SUBJECT: ENGINE CONTROLS - MODIFICATION OF CARBURETOR THROTTLE ARM ATTACHMENT

Service Instructions No. 0589-159, Rev. I

Service Instruction No. 1265A
(Supersedes Service Instruction No. 1265)
Engineering Aspects are
FAA (DEER) Approved

SUBJECT: Serrated Throttle Lever and Shaft
MODELS AFFECTED: Normally aspirated Avco Lycoming engines.
TIME OF COMPLIANCE: As required; during carburetor overhaul.

Figure 2. New Throttle Arm Configuration Showing Serrated Faces of Arm and Stop Levers

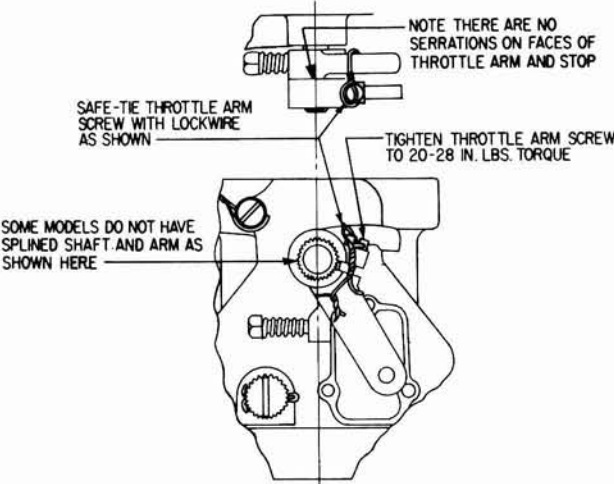
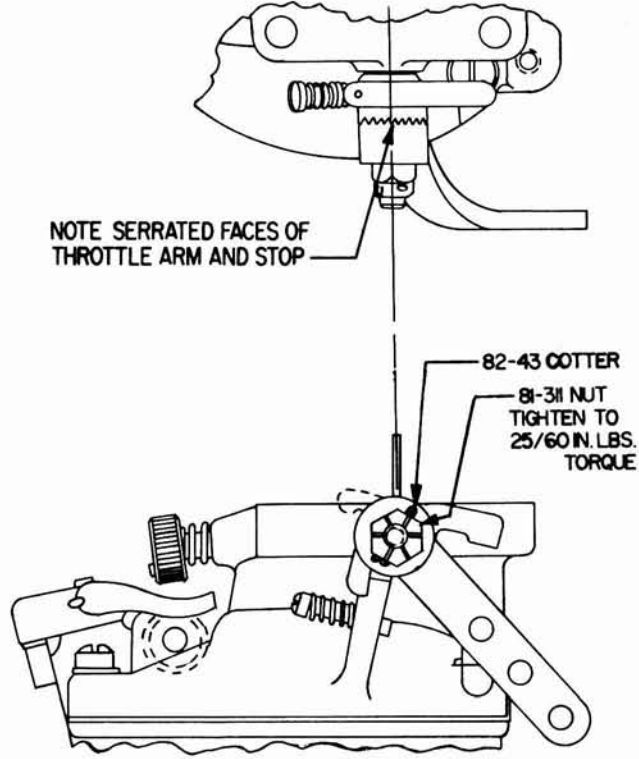
The superseded lever was tightened on the shaft by the clamping action of the attaching screw and secured

with lockwire. See fig. 1. The serrated feature of the new lever and shaft insures positive locking and eliminates the requirement for safety wire and torque requirements as specified in Service Bulletin No. 330A.

NOTE: Revision "A" adds part nos. and torque value on fig. 2. Removes detail parts from list. Removes non-applicable assemblies from list.

All Marvel-Schebler carburetors are now being furnished and serviced with serrated throttle levers and shaft. Refer to Marvel-Schebler Aircraft Carburetor Manual for overhaul and modification instruction. The new components in the following list replace the old smooth shaft and throttle lever assemblies. They are adjustable 360° in increments of 15°.
